**ARCHITECTURAL REVIEW BOARD  
MUNICIPAL PLANNING COMMISSION  
-AGENDA-  
Thursday, June 25, 2026 at 7:00 P.M.**

SUBJECT: Staff Memo for the Meeting of June 25, 2026

**1. Rezoning – PUD Preliminary Plan – 445 E. Granville Rd. (Elford Development/ Boundless)  
PUD 01-2026**

<b>PRELIMINARY GRADING PLAN</b>		SCALE:	1" = 60'
		SHEET NO.	6 OF 6

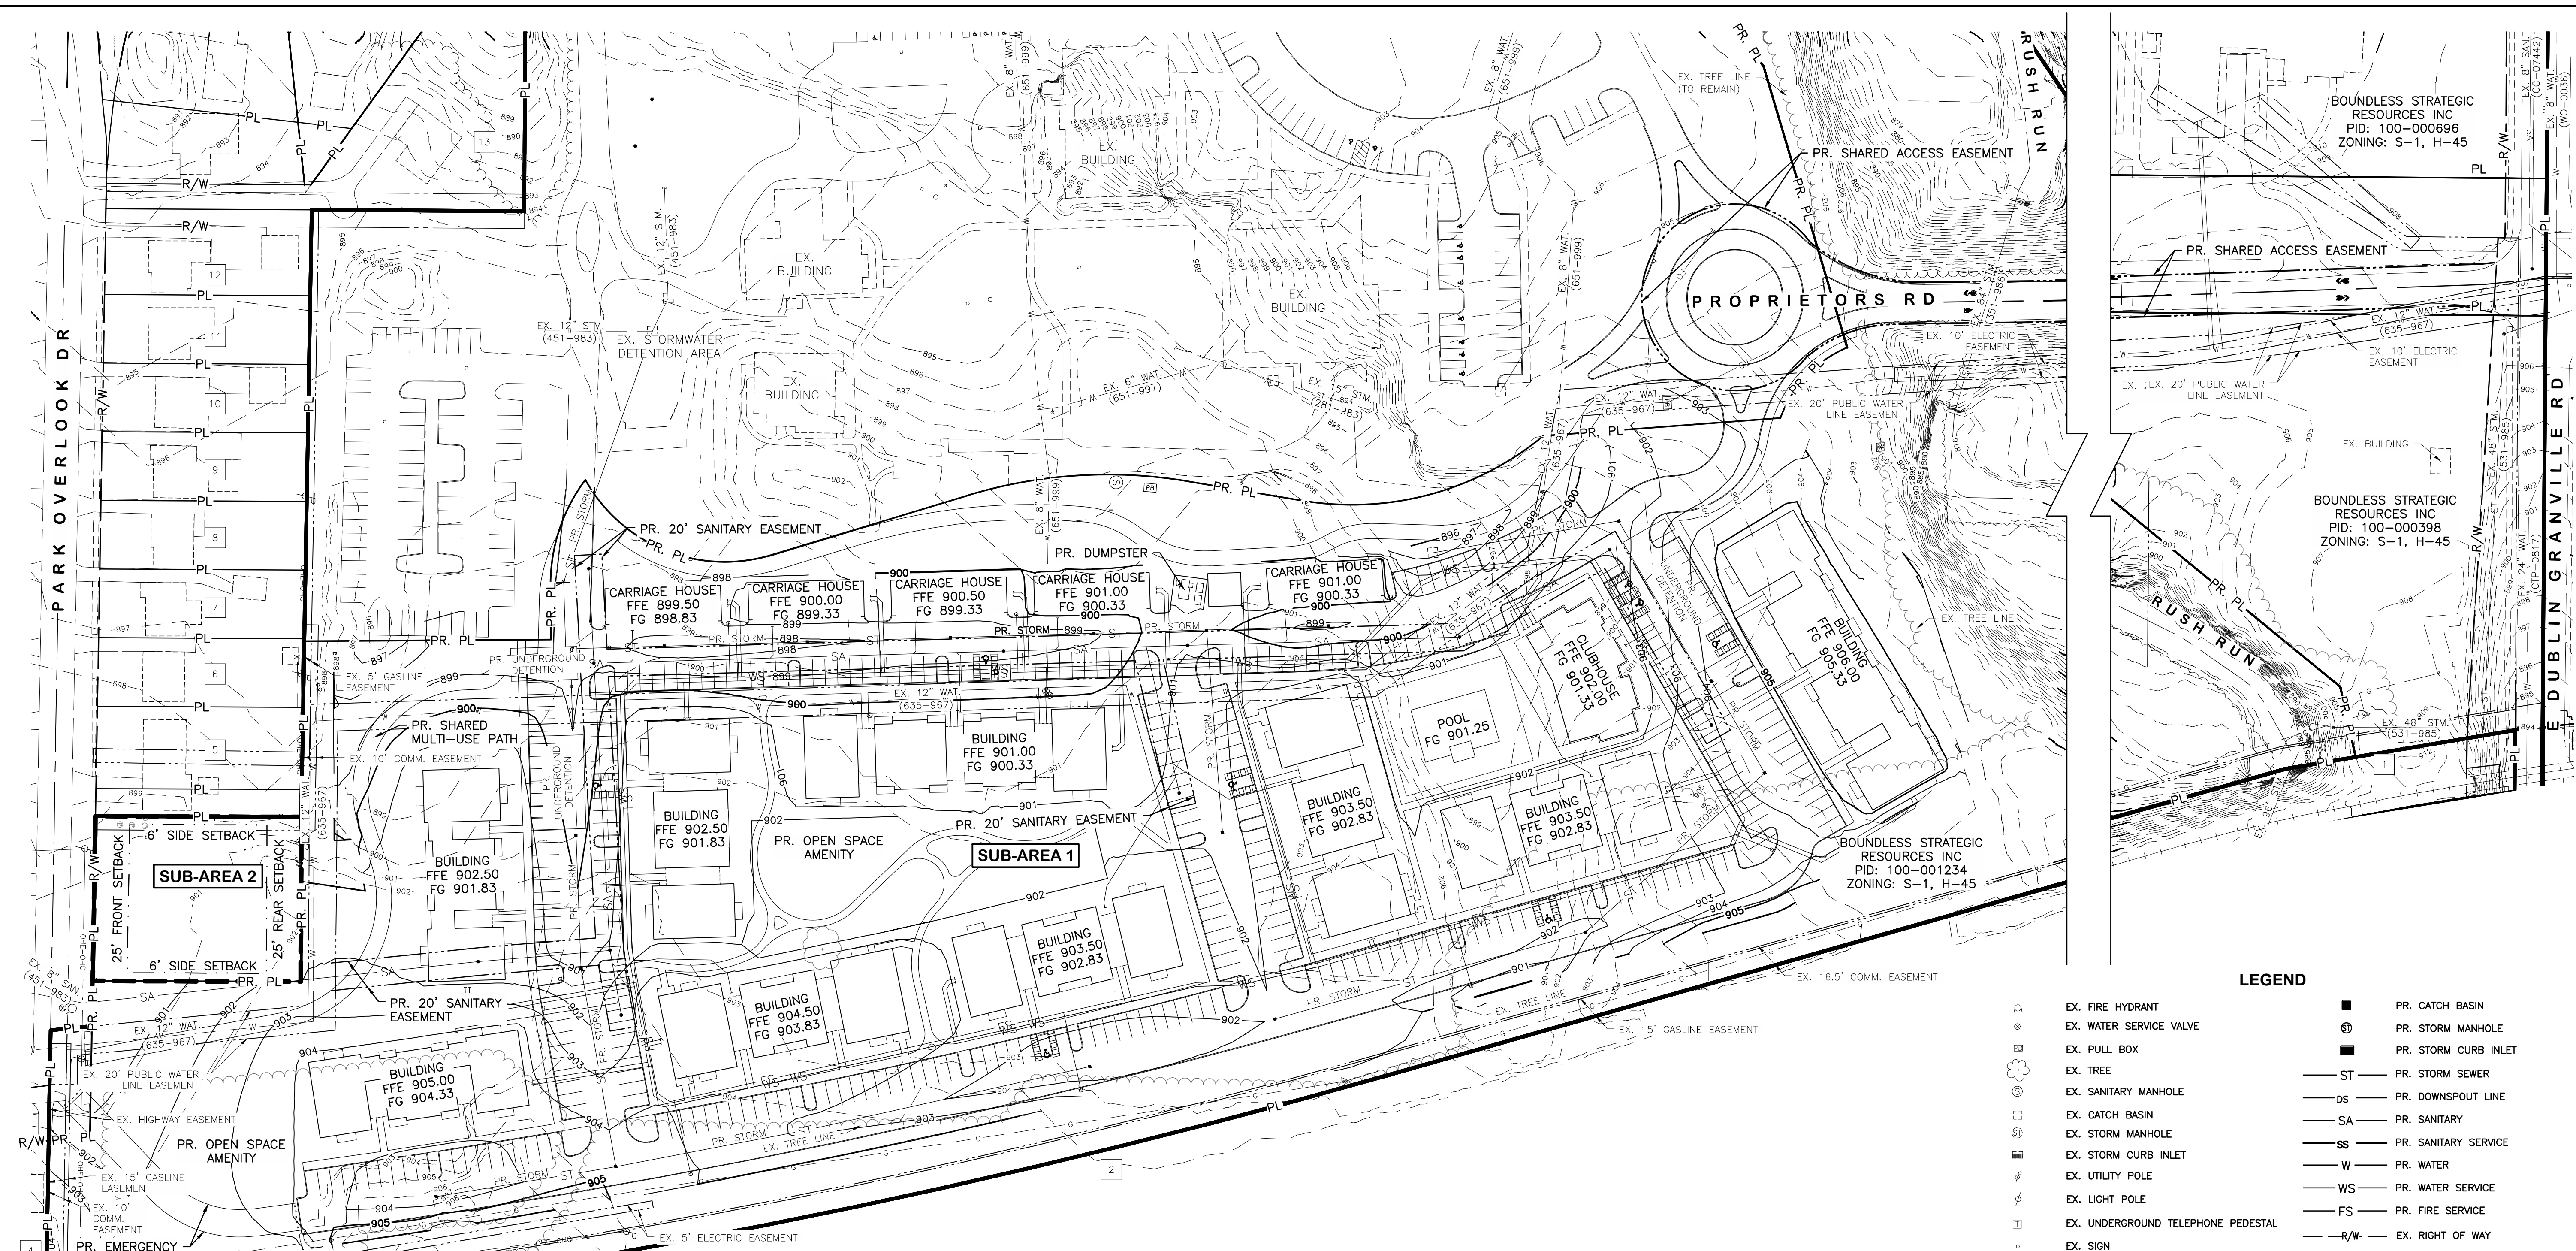
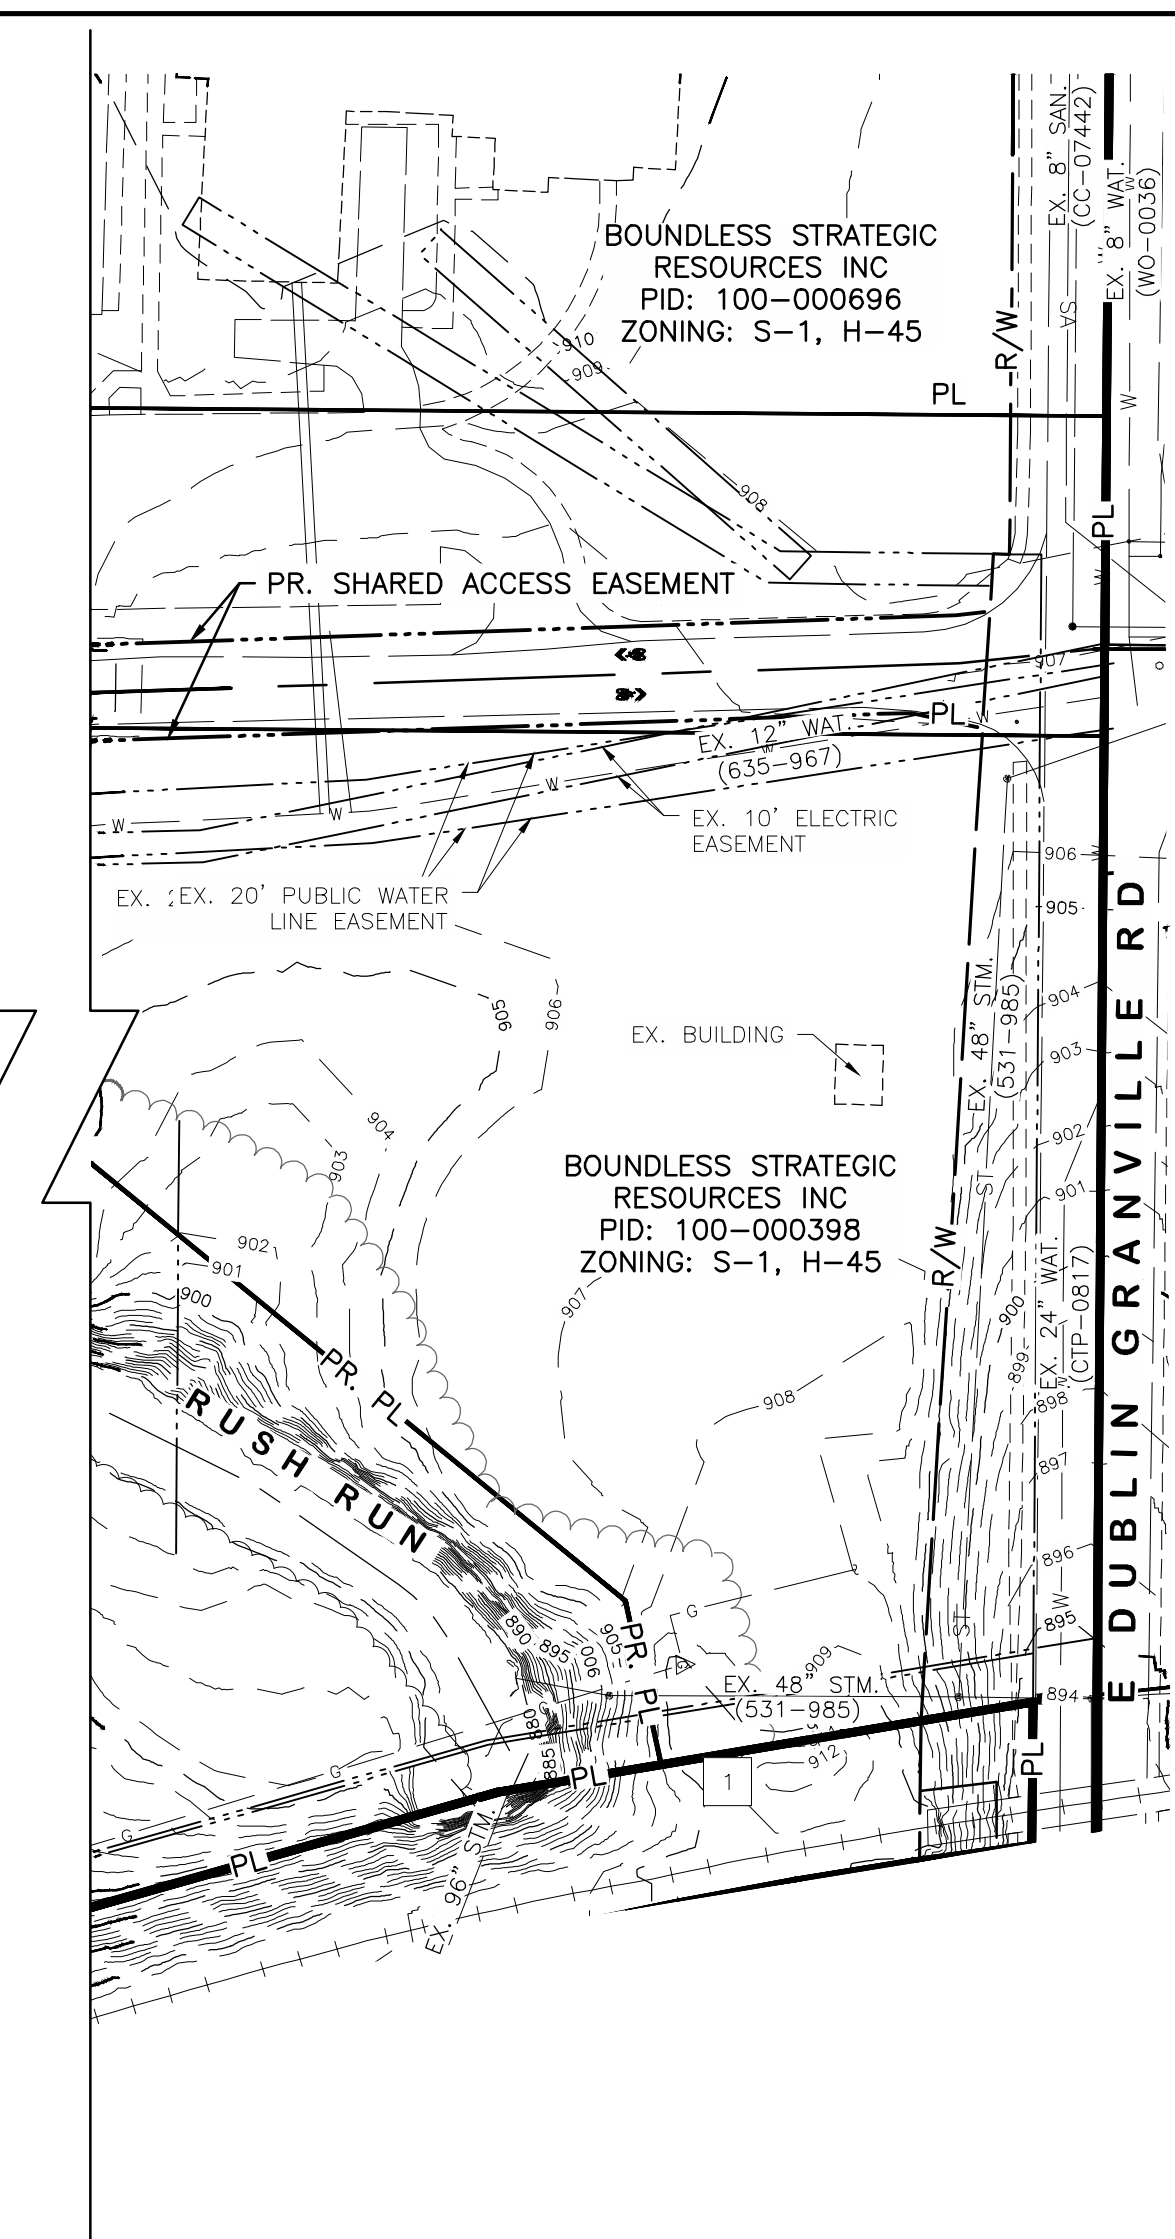
- d. Preliminary Grading Plan (page 31 of 58)
  - e. Site Layout Plan (page 29 of 58)
  - f. Site Utility Plan (page 30 of 58)
  - g. Dwelling Units/Acre:  
246 multi-family + 2 single-family = 248 units ÷ 20.4 acres = 12.2 units/acre

**1** Tree Preservation Plan  
SCALE: 1" = 80'-0"

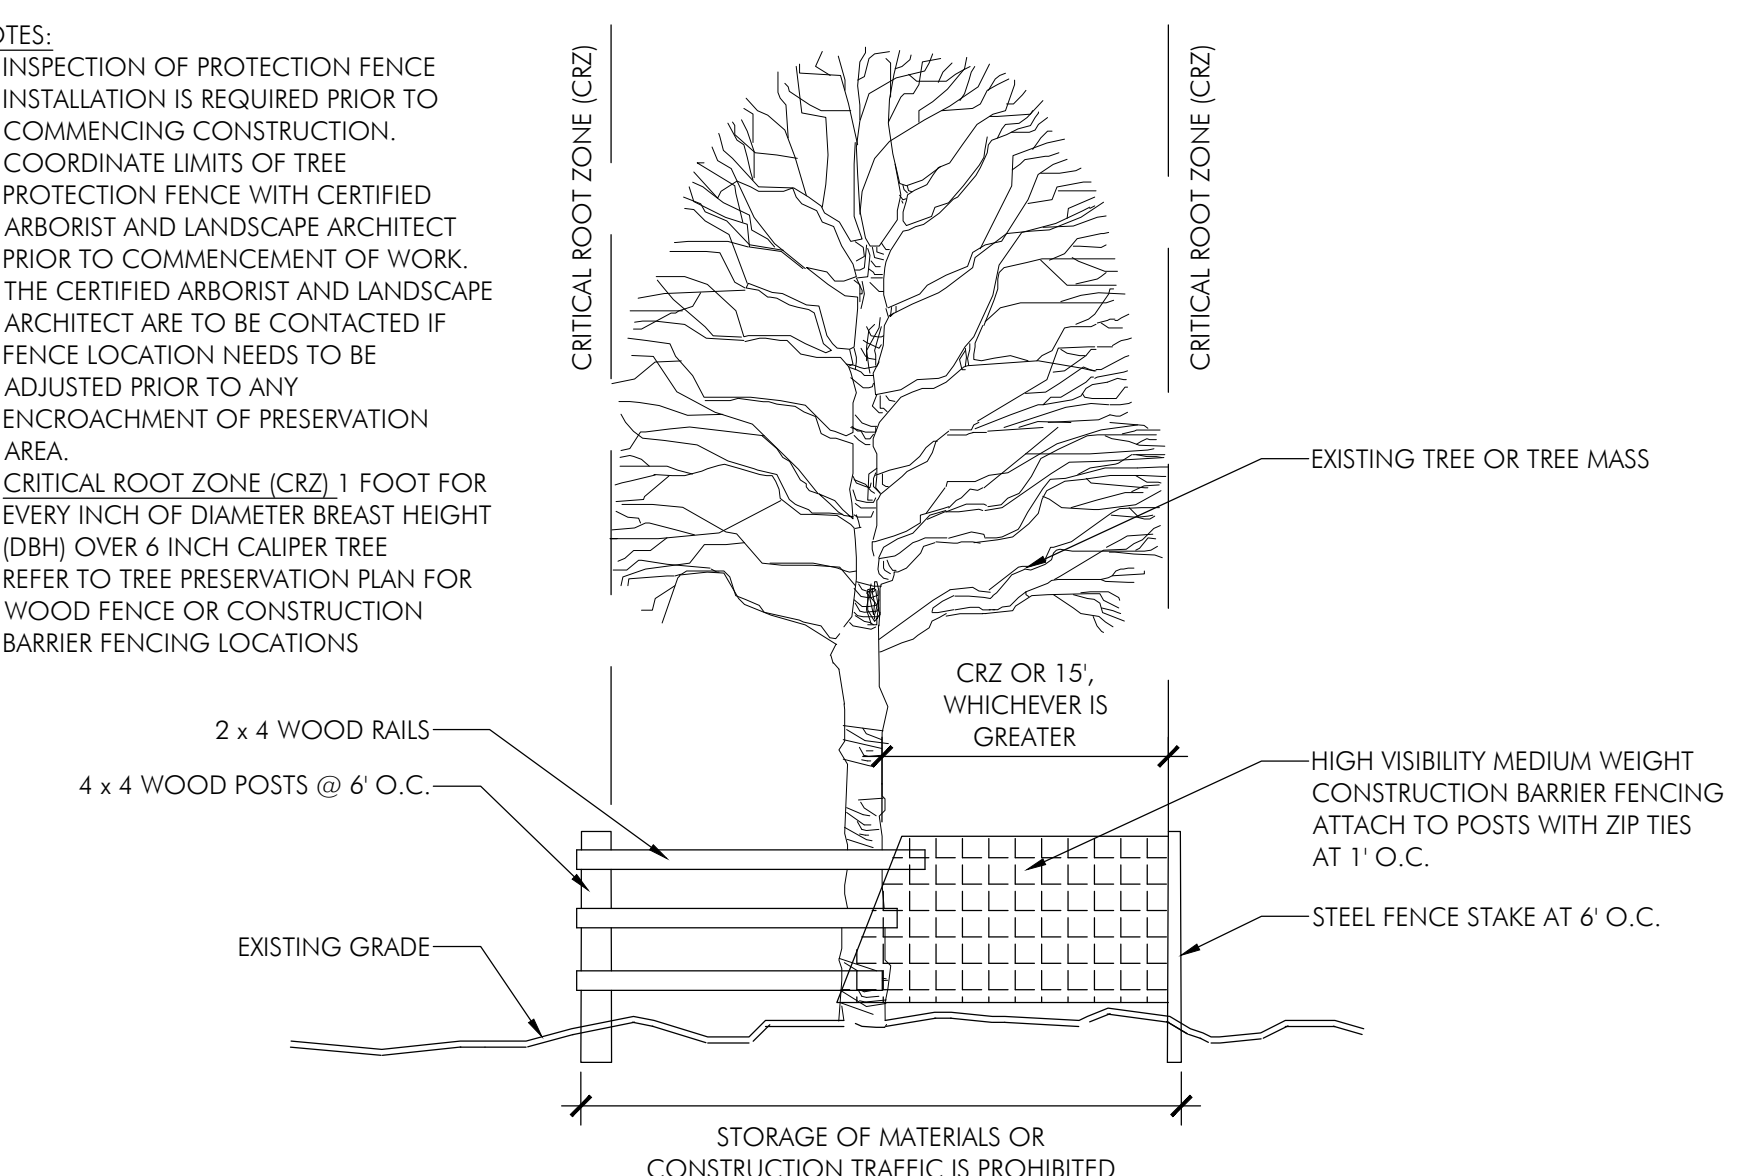
- 1) Tree Preservation/Replacement
    - All trees 6” and larger have been identified and the condition evaluated in consultation with a City Arborist. Alignment was slightly modified to save certain trees.

- Preserved trees will be fertilized and pruned (if needed) two years after construction
    - Any trees removed or damaged in conflict with the Tree Preservation Plan will be replaced
